UNITED STATES PATENT AND TRADEMARK OFFICE

Office Action Summary	Application No. 10/824,110	Applicant(s) EISENBRAUN, KENNETH D.	
	Examiner Amy J. Sterling	Art Unit 3632

This is the second non-final Office Action for application number 10/824,110 Merchandising Hanger, filed on 4/14/04. Claims 1-18 are pending. This is the second non-final Action is in response to applicant's Appeal Brief dated 10/19/05. The text of those sections of Title 35, U.S. Code not included in this action can be found in a prior Office action.

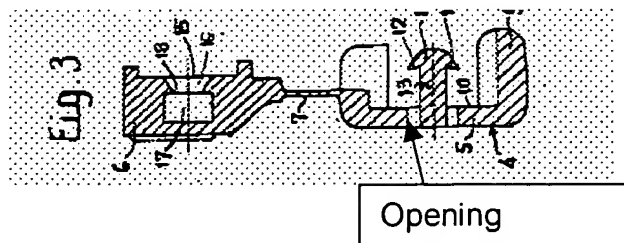
The patent to Swift et al. discloses a single piece hanger (10) molded of a thermoplastic material (See Col. 2, line 43 for material) having a planar surface (30) having a top and a base, a tab (16) extending from the base of the surface, the tab

having a stud (24, 28, 29) with a body (29) and a hemispherical conical cap (24,28), the stud which is integral with one of the first portion (14) and an aperture (20) having a flange divided into a plurality of flange portions (22) therein through a third tab portion (12), the first tab portion having a first tab portion thickness, the third tab portion having a third tab portion thickness and an intermediate between the first and third tab portions is a second tab portion (18) having a second tab thickness which is less than the first tab portion thickness.
